Western Sub Regional RTEP: AEP Supplemental Projects

February 16, 2024

Changes to Existing Projects

S2831: Posted in 2023 Local plan. Need Number: AEP-2022-IM011
Supplemental Project Driver: Customer Need
Problem Statement:

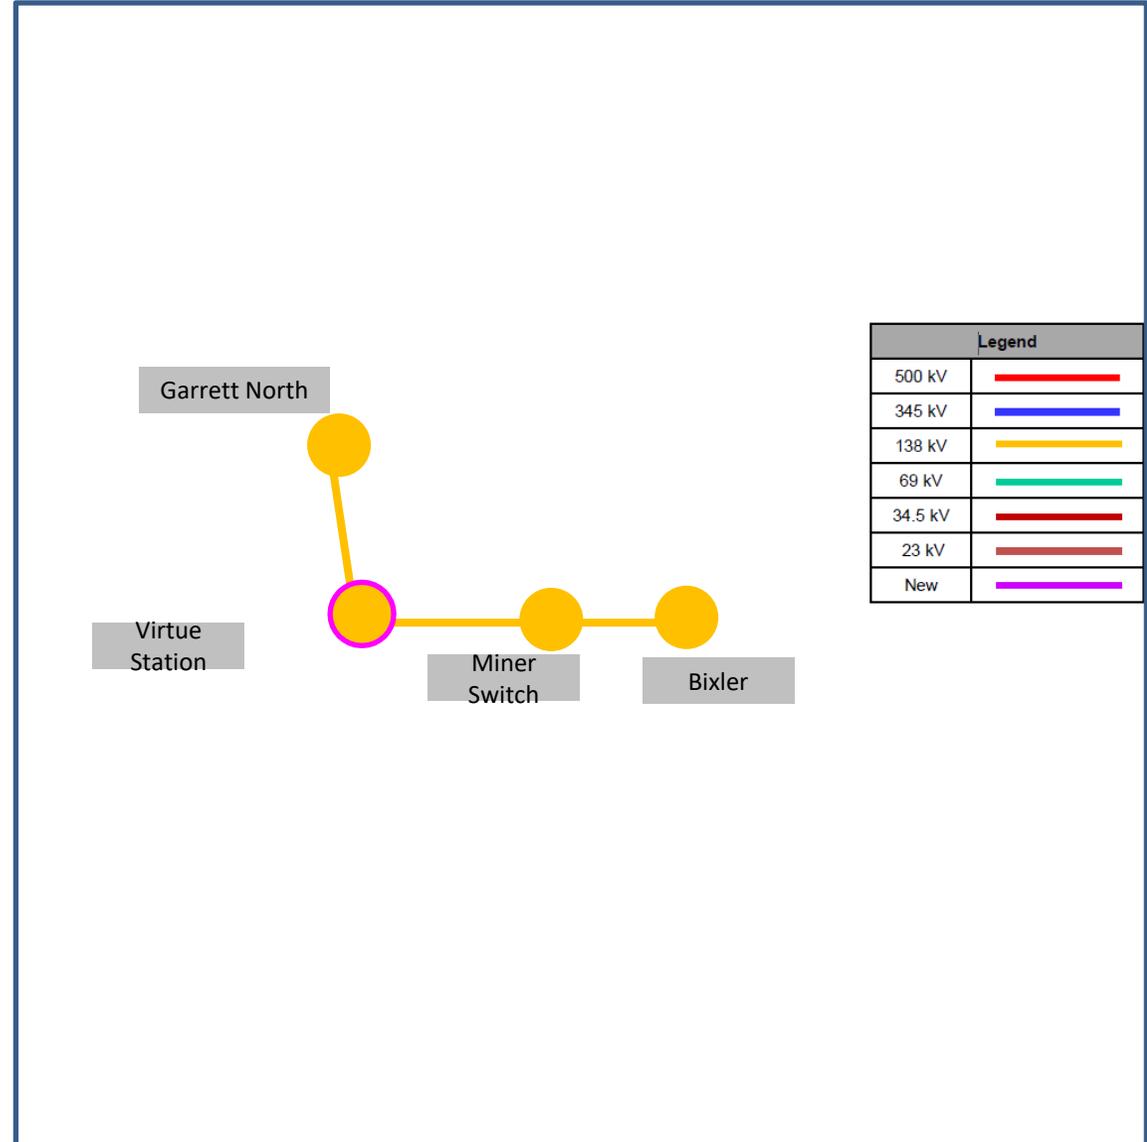
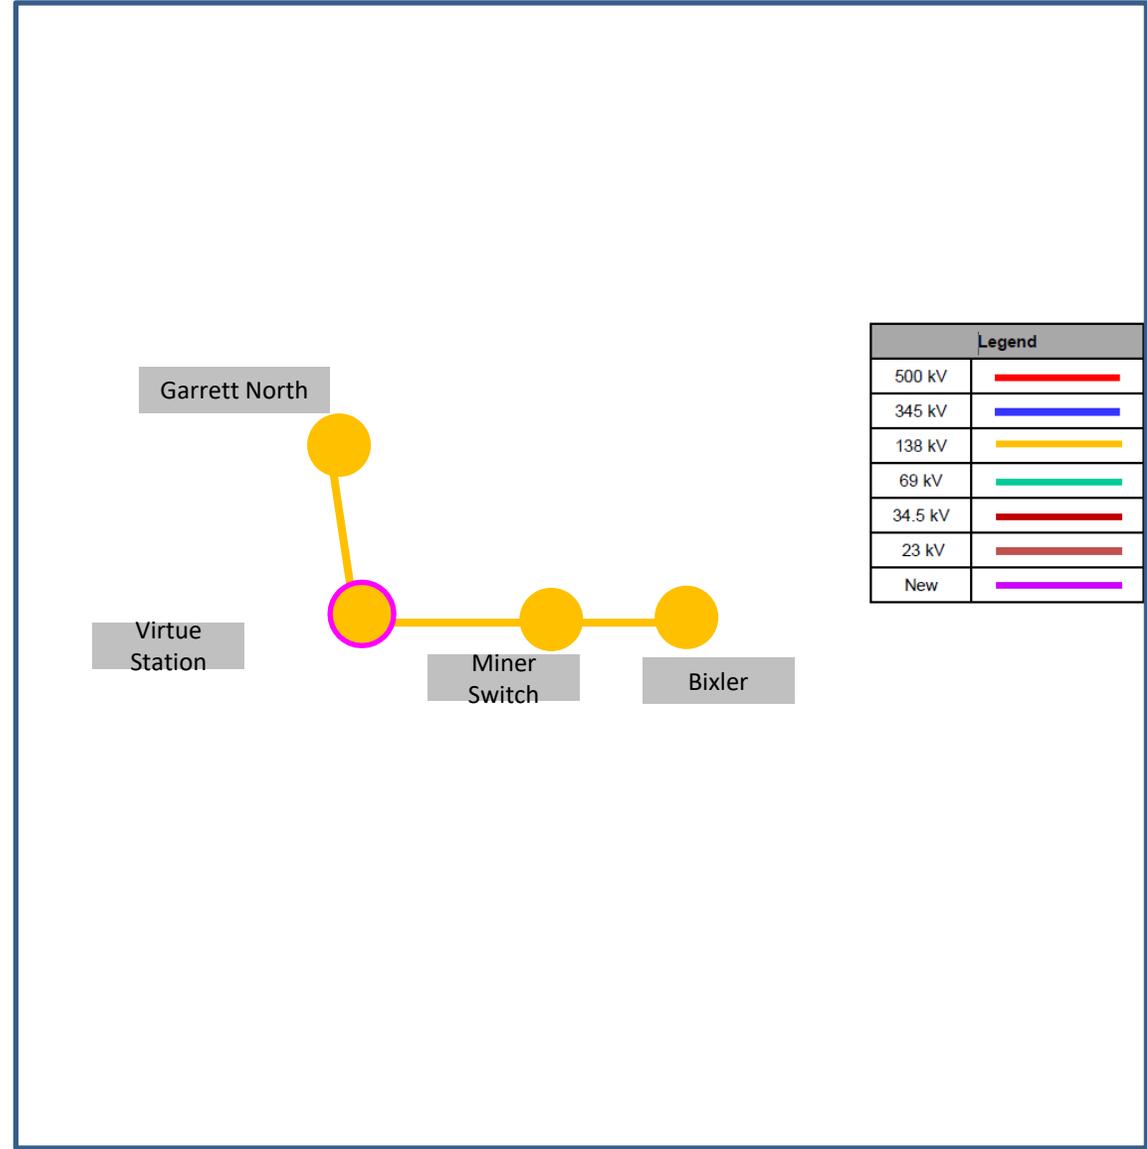
Reasoning for change:
 At the time of submittal, a land option was not yet selected, and the scope had anticipated a land option close to the existing Noble station. The land option that has been chosen for this station rebuild is neighboring the 138kV line. Due to the proximity of the 138kV line, this project is moving forward with the alternate option of rebuilding the station at 138kV. This scope will avoid complicated line crossings under an existing 345kV, to re-terminate the new station onto the 69kV line.

S2831 New Scope:

Retire 69kV Noble station. Re-terminate 69kV Auburn-Kendallville 69kV line outside of Noble station. (S2831.1)

Install 138kV bus, 15.4MVAR Capacitor with 138kV circuit breaker, 2x 138kV MOAB to serve new distribution station. Install Telecom at Virtue station and remote ends. (S2831.2)

The alternate was re-evaluated and selected for this project based on the available land to build the station on. The original proposal, by crossing the 345 kV line and connecting back to the 69 kV line, would result in higher costs to complete. **Estimated cost: \$4.7M**
